MUELLER DESIGN BOOK

ADDENDUM B: AMENDMENT

(FEBRUARY 2009)

REVISED GUIDELINES FOR AUSTIN FILM SOCIETY CAMPUS

Austin Film Society Lease Area

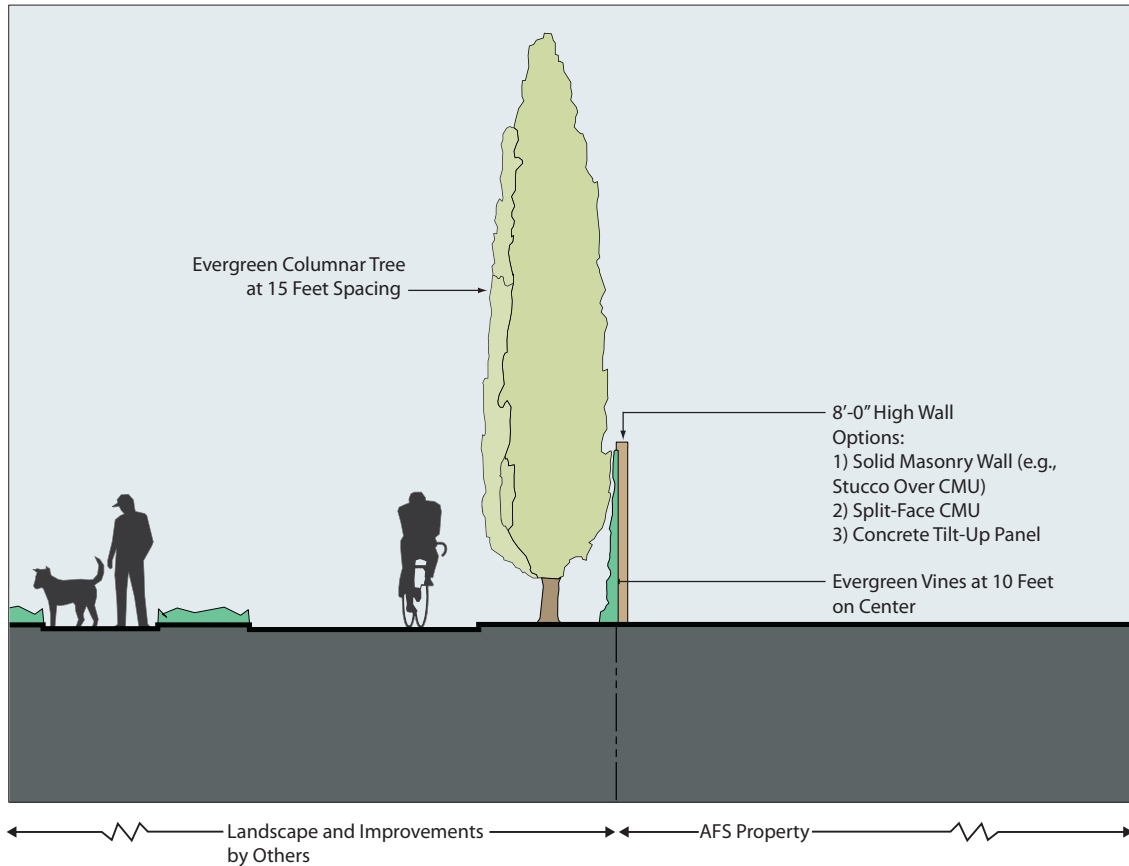
- Truck and vehicular access to the AFS campus will be primarily from driveways connecting to East 51st Street or from Old 51st Street fronting the National Guard Site. Tilley Street may also be used as a secondary access and egress, with a maximum of one curb cut to be aligned exactly with the shared driveway/access for CTECC and the GLO properties, as shown on the plan diagram below. Driveway widths shall not exceed 24 feet in width.

Austin Film Society Screen Wall

- Along the western (Vaughan Street) and southern (Philomena Street) boundaries of the AFS lease property, an eight-foot tall perimeter wall will be constructed, creating an attractive public appearance and providing security and visual privacy for AFS. The wall should be constructed of high quality materials, such as pre-cast concrete, brick or other masonry. Murals or other artistic elements that convey the creative film-making activities of the complex are encouraged to be integrated with/into the screen walls. Along the AFS’s northern (East 51st Street) and eastern (Tilley Street) boundaries, a see-through fence will be constructed. The use of wrought iron tubular steel and other decorative high quality materials and treatments is recommended.
